May 26, 2021

RE: 16529 Marchmont Drive

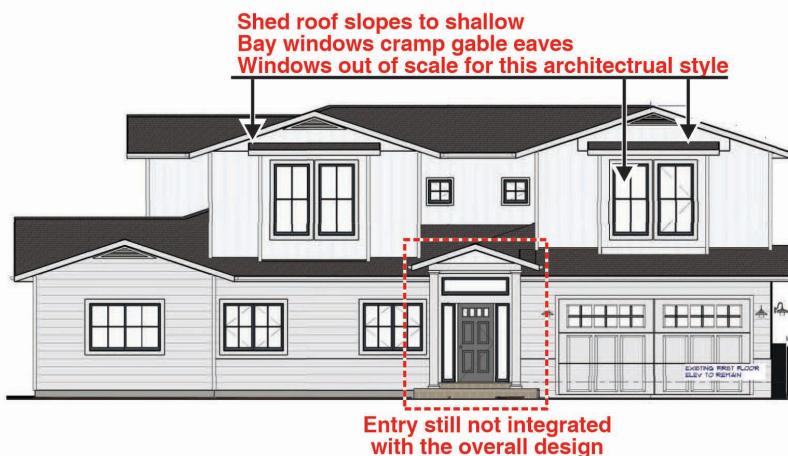
When reviewed in March, a few issues were identified as needing further attention - see illustration below,

Each of the concerns has been addressed in this submittal - see sketch below.

While the changes were largely consistent with the March recommendations, there are just a few small refinements that I would recommend to address the issue shown on the illustration below.

1. Increase the roof slope to be more consistent with the architectural style, and to reduce the cramped appearance of the bay windows relative to the facades and gable ends (an approximate 6/12 roof slope is shown on the illustration, but a somewhat lower slope might be acceptable).

2. Reduce the window size to be more consistent with the architectural style. The proposed second floor windows appear to be more than six feet in height with sills very close to the floor line. By contrast, the general standard for homes in this general traditional architectural style are smaller - see the illustration to the right of a typical bay window from the Anderson windows.

3. Match the second floor shed roofs to the main roof slope.
4. Refine the entry to better integrate it with the overall design.
 - *Improve the proportions, and match the gable inset more to the overall facade design and materials.*

- *Lower the projecting entry eave to match that of the main roof.*
 - *Lower column capitals to better relate to human scale.*
